Executive Director's Recommendation

Commission Meeting: September 3, 2026

PROJECT Lafayette Park Security Improvements President's Park 1600 H Street, NW Washington, DC	NCPC FILE NUMBER 8802 NCPC MAP FILE NUMBER 1.32(70.00)46256
SUBMITTED BY United States Department of Homeland Security, United States Secret Service	APPLICANT'S REQUEST Approval of comments on concept plans
REVIEW AUTHORITY Federal Projects in the District per 40 U.S.C. § 8722(b)(1) and (d)	PROPOSED ACTION Approve comments on concept plans ACTION ITEM TYPE Staff Presentation

Fencing Alternative – Alignment 1 (Preferred)

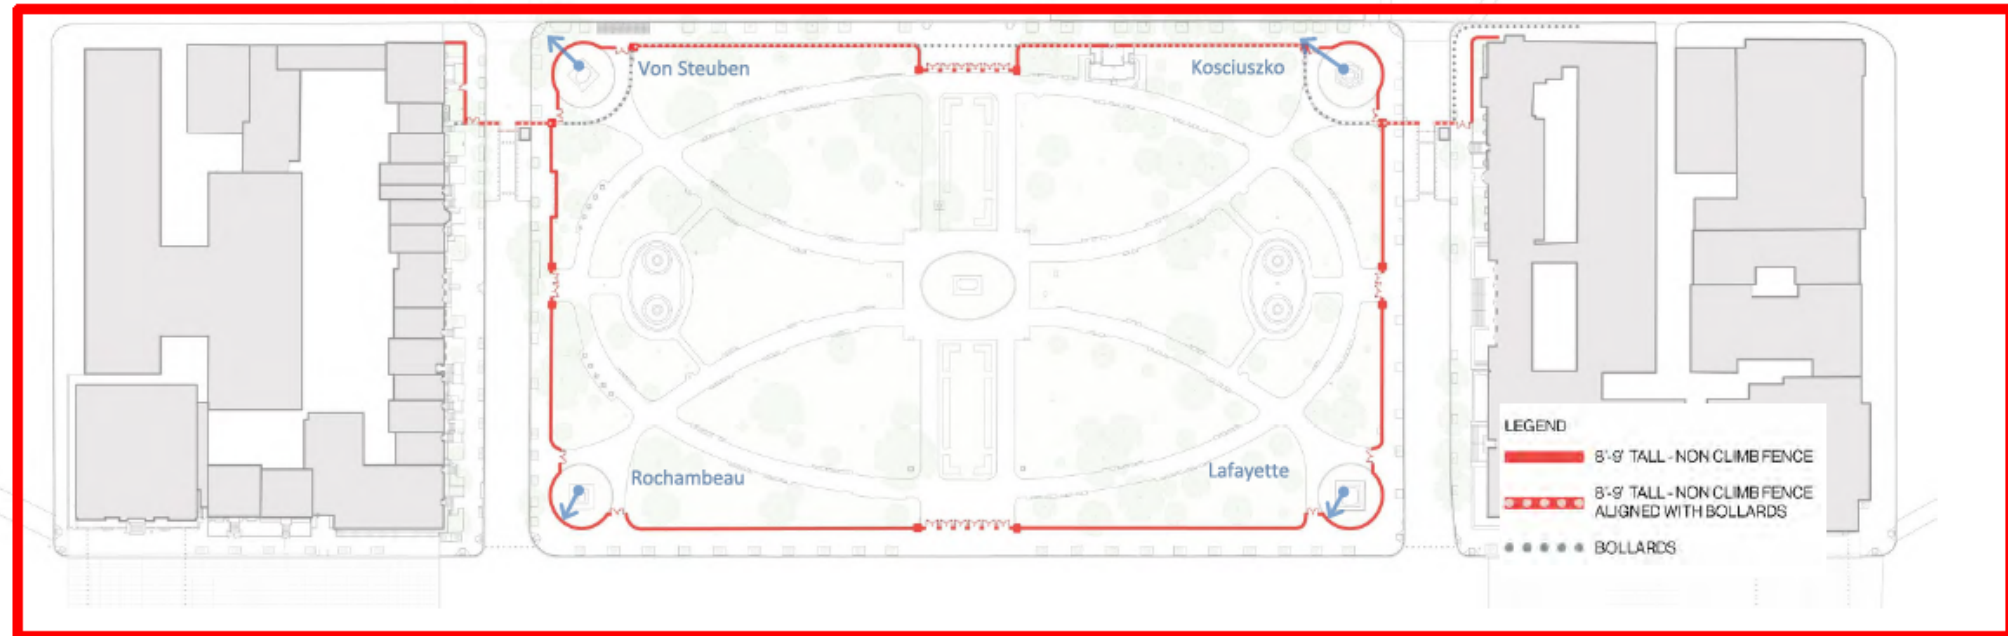
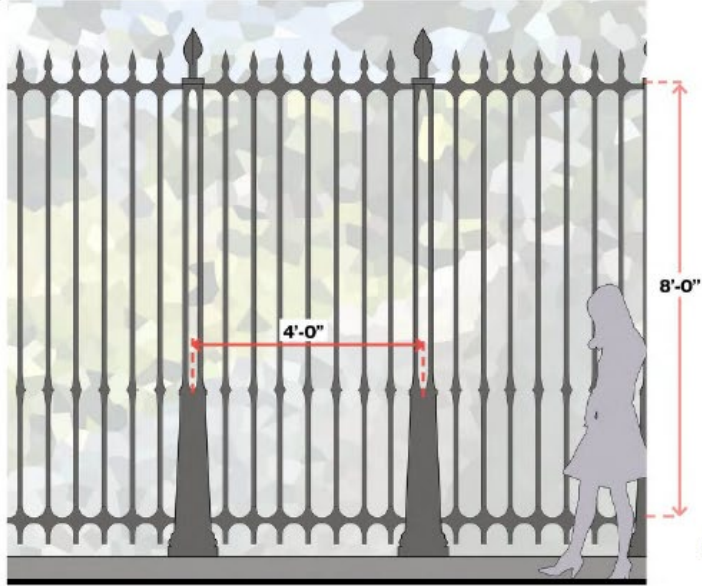
- Alignment 1: Effectively integrates the existing perimeter, preserves the continuous elliptical pathway within the park, and has the most physical and visual porosity; however, it encloses the entirety of the park and the multitude of metal posts and gates across the H Street entrance lacks a welcoming arrival experience.

Supports the applicant's preference for fence Alignment 1 as it is the most integrated with the existing perimeter, creates a plaza space for First Amendment gatherings along H Street, NW during temporary full closures, and maintains uninterrupted circulation within the park.

Recommends further development of the fence alignment at the corner statues and the approach for the center entry gates to achieve a balance between physical and visual openness and a design that is inviting to the public.

FENCE ELEVATION AT H STREET

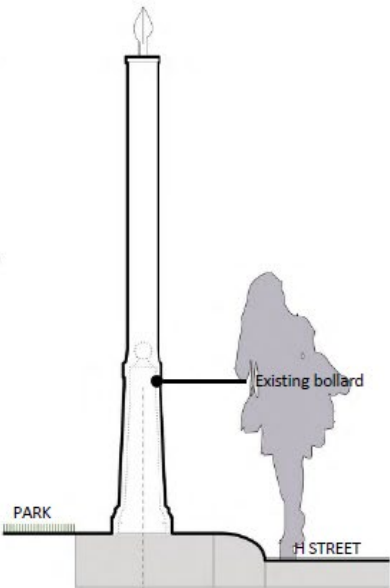
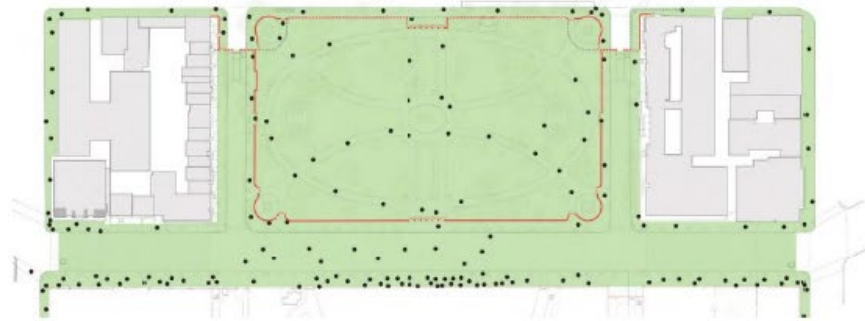
Finds the proposal to incorporate the existing bollards into a tapered fence post base provides a creative solution to consolidating security measures.

Finds the open, double-picket post design above the rounded tapered fence post base visually integrates the posts with the panels and adds transparency. The solid fence post and squared options above the integrated base emphasize the height of the fence and create visual density at four-foot spacing.

Fencing Alternative – Alignment 2

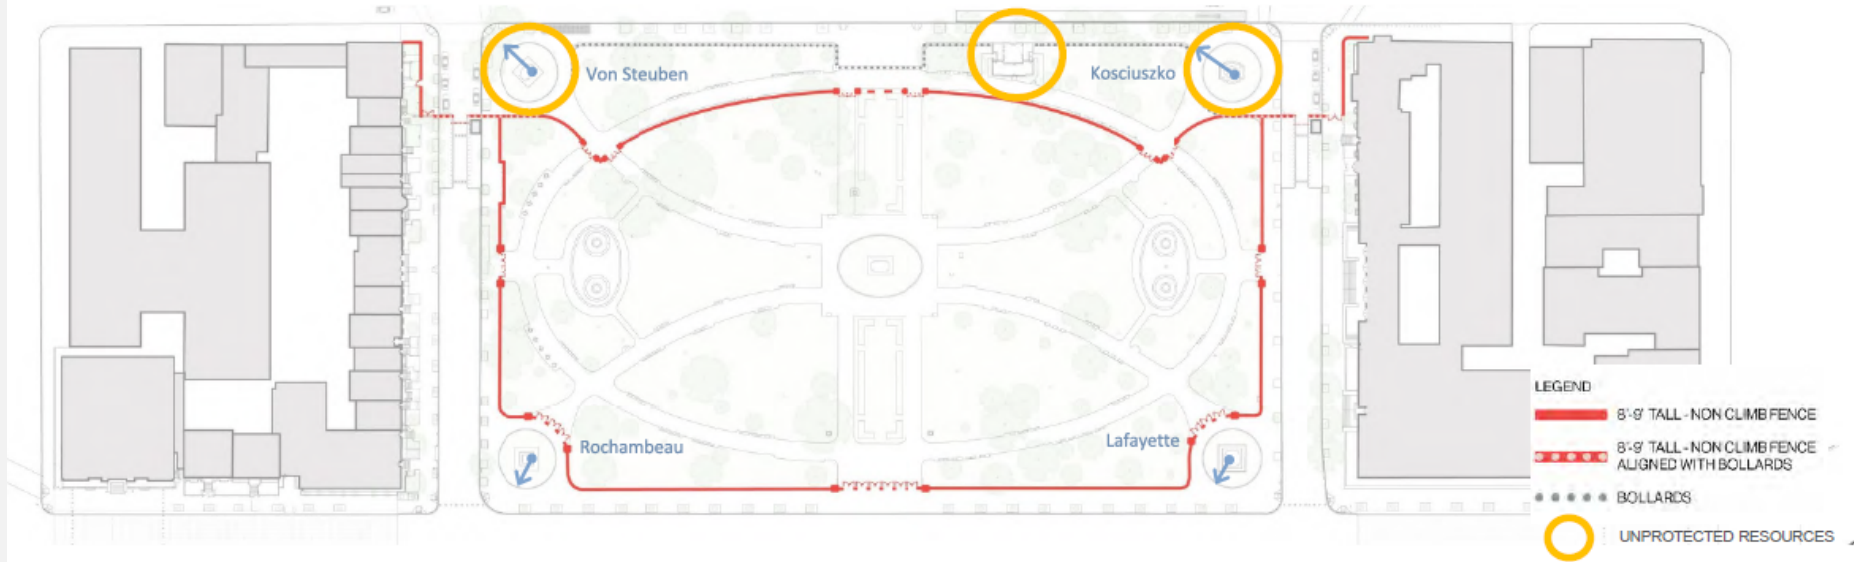
- Alignment 2: Provides more space for First Amendment gatherings along H Street, NW during temporary full closures; however, much of the unenclosed space is landscaped with mature trees that may be affected by soil compaction from pedestrian activity. It also introduces an additional fence line inboard of the existing bollards and interrupts the continuous elliptical pathway within the park with fencing and gates.

Fencing Alternative – Alignment 3

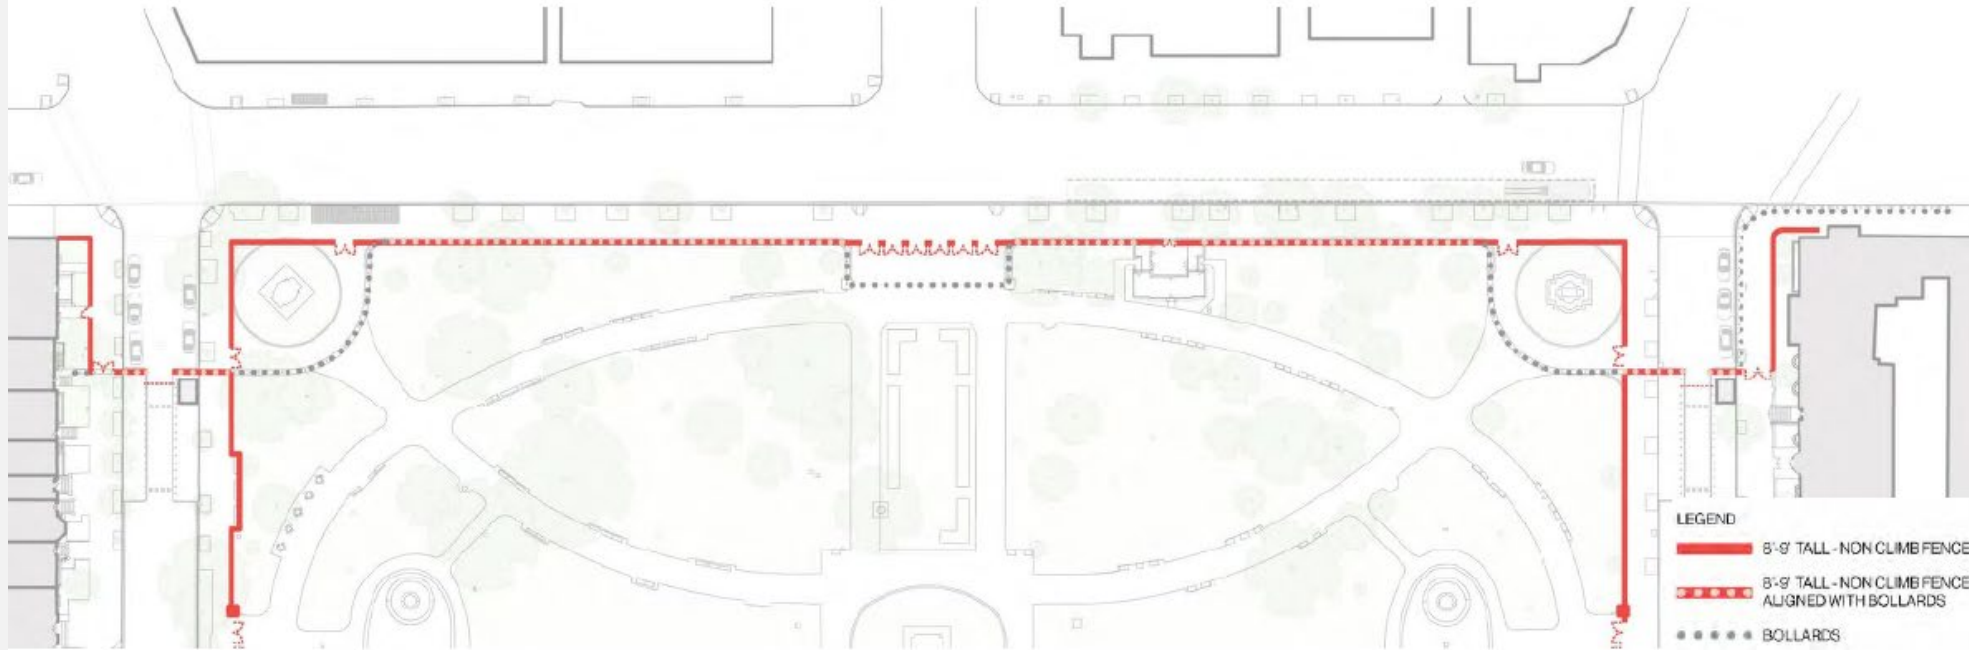
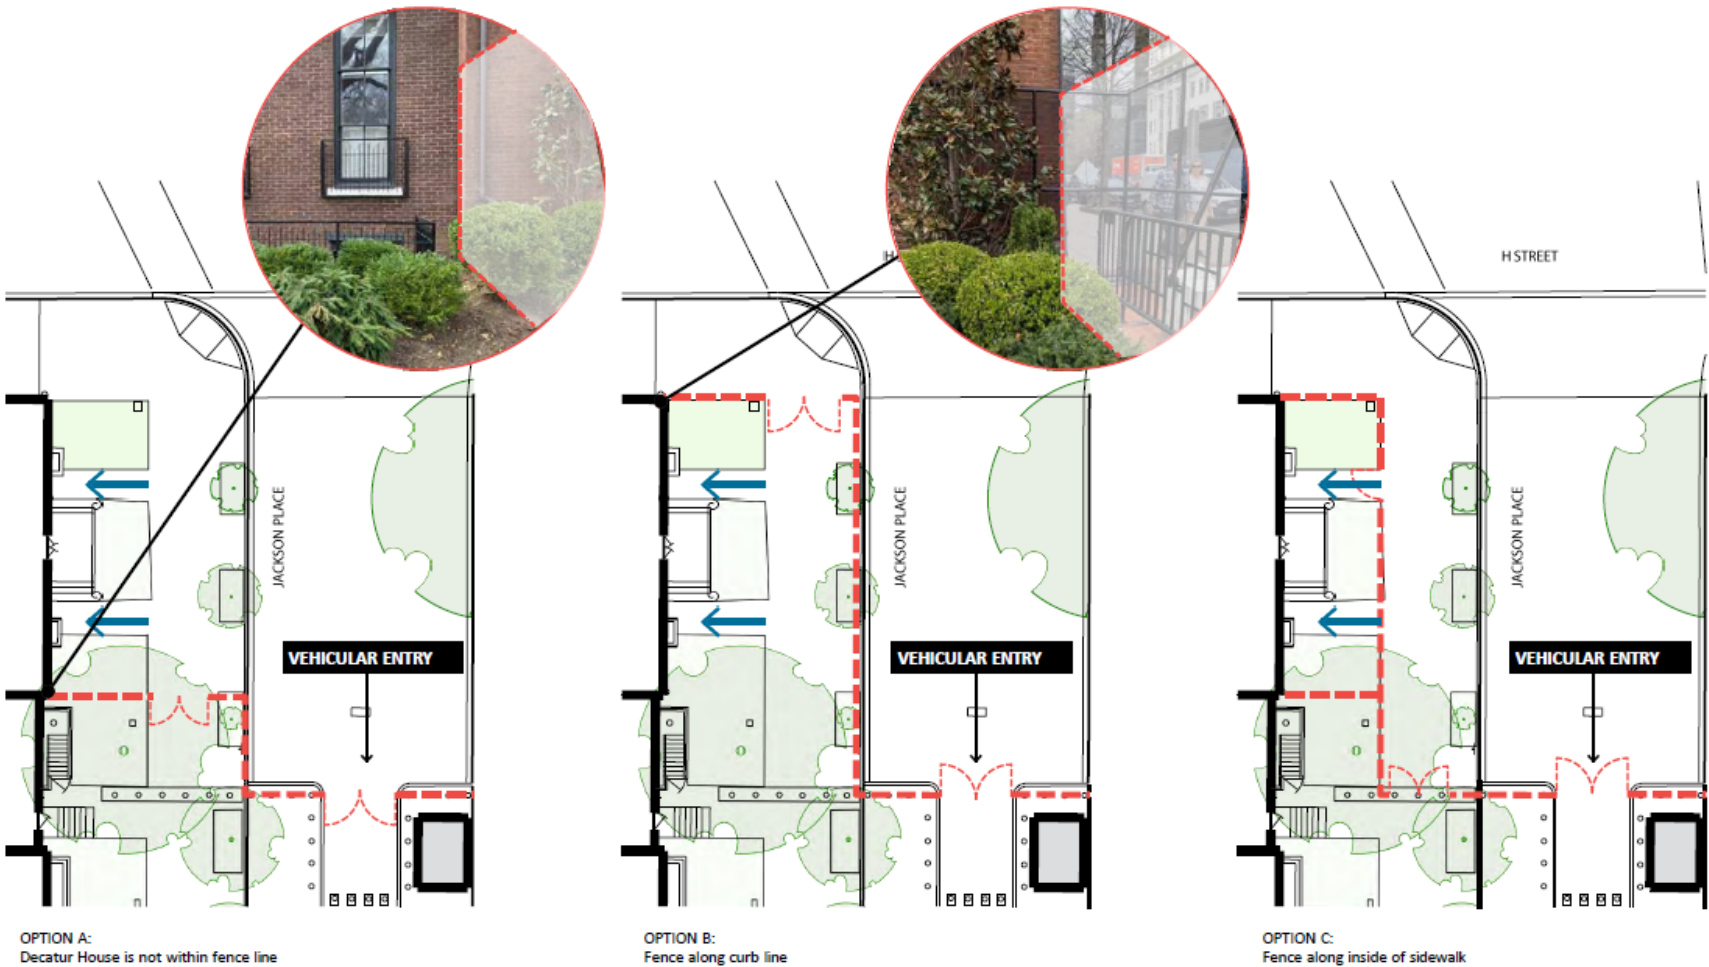
- Alignment 3: Reduces spatial constraints around the corner statues with the right-angle fence alignment. However, it provides limited space for First Amendment gatherings at the north center entry, which is inconsistent with the park's character and use.

Character Exploration – Comparison to White House Fence

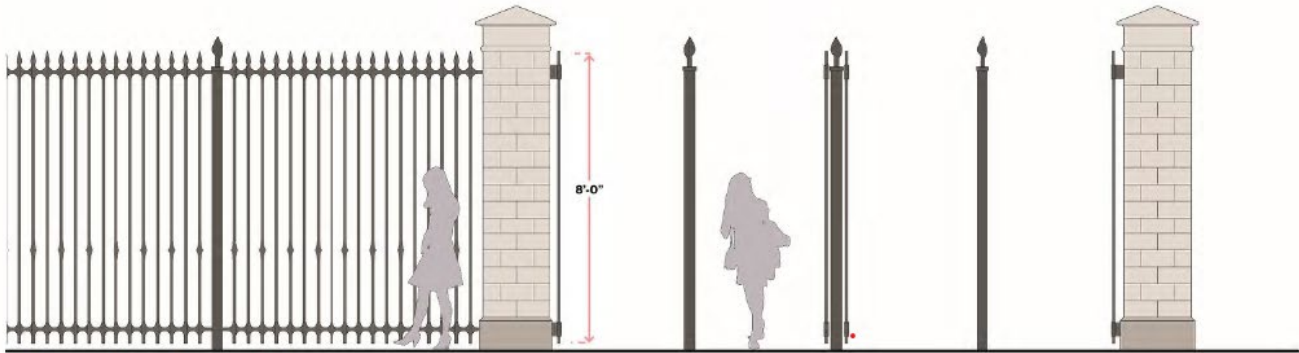
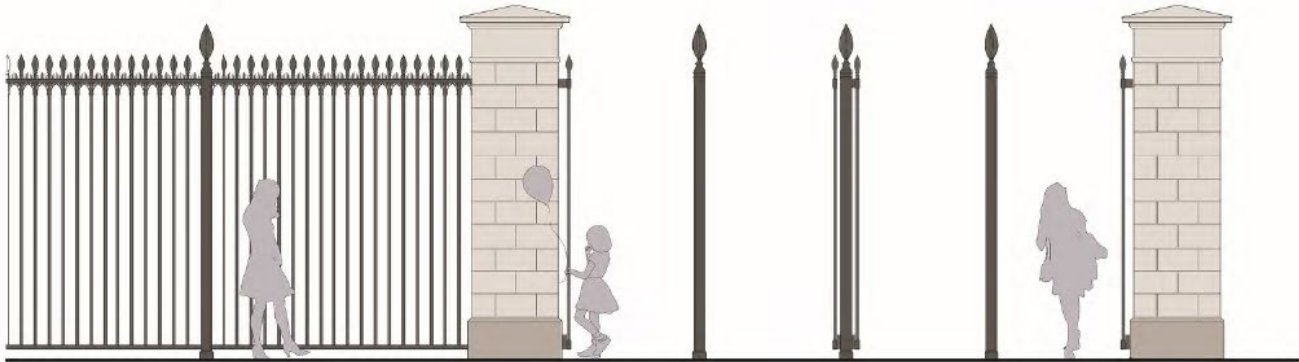
Finds the proposed Lafayette Park fence design also achieves visual continuity with the White House fence through its overall form, picket spacing, and incorporation of the columns at the center entry gates.

Park Hardscape – Options Considered

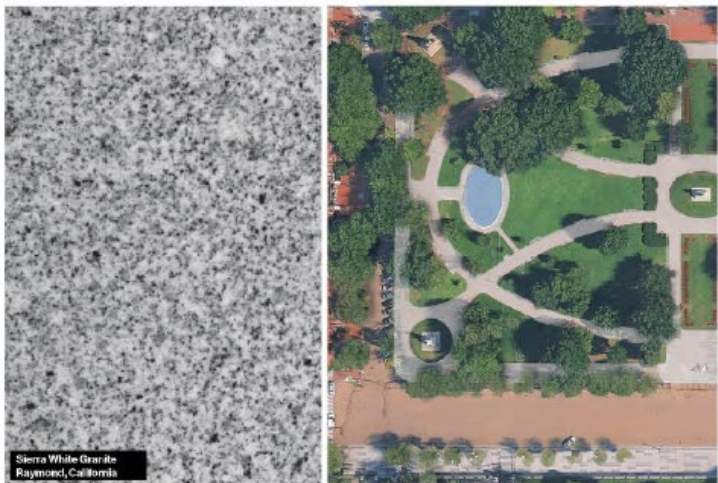
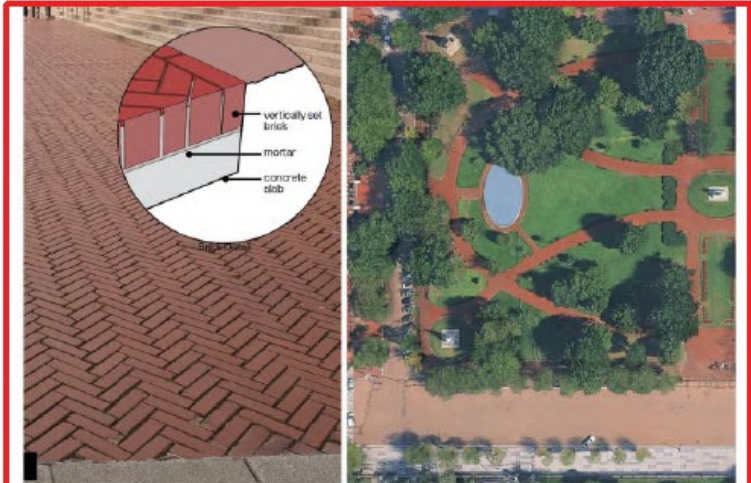
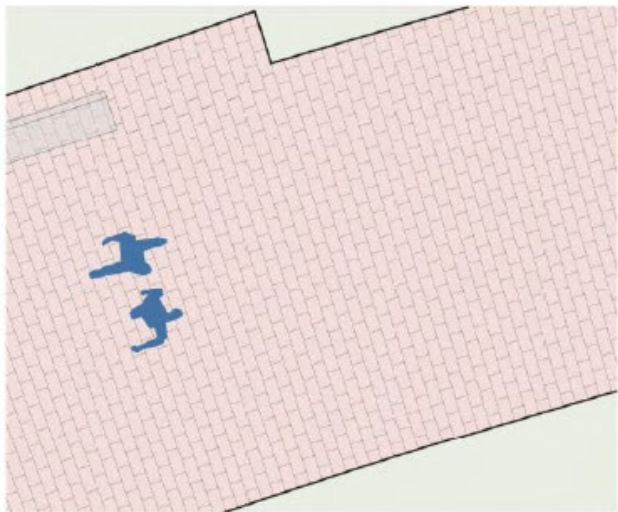
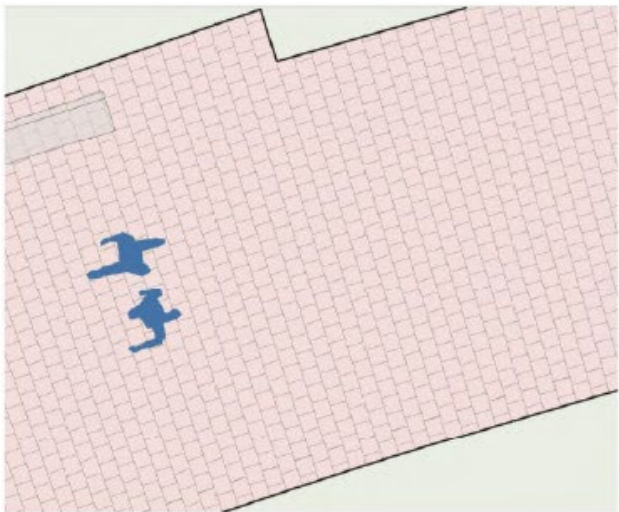
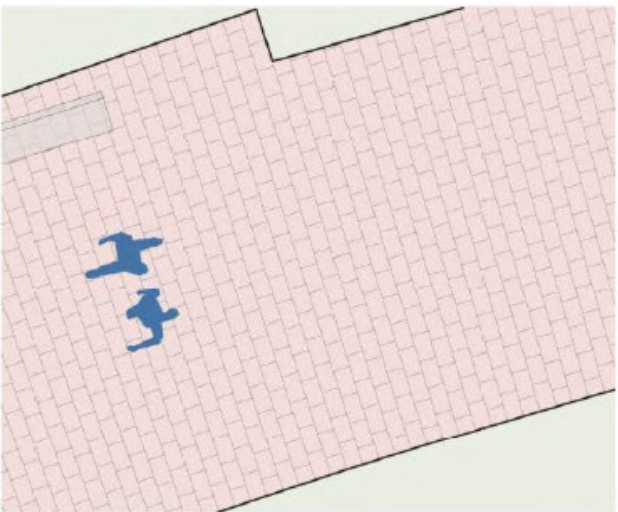
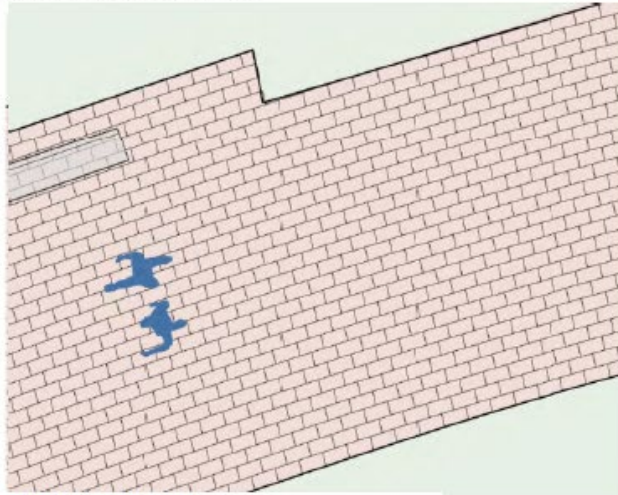
Notes the concept plan submission also includes options considered for paving modifications within the park and **supports** the applicant's preferred approach to reuse the existing pavers with an enhanced depth of placement to ensure a more stable installation.

Recommends the brick pattern and direction are evaluated in coordination with the Consulting Parties as part of the National Historic Preservation Section Act 106 process.
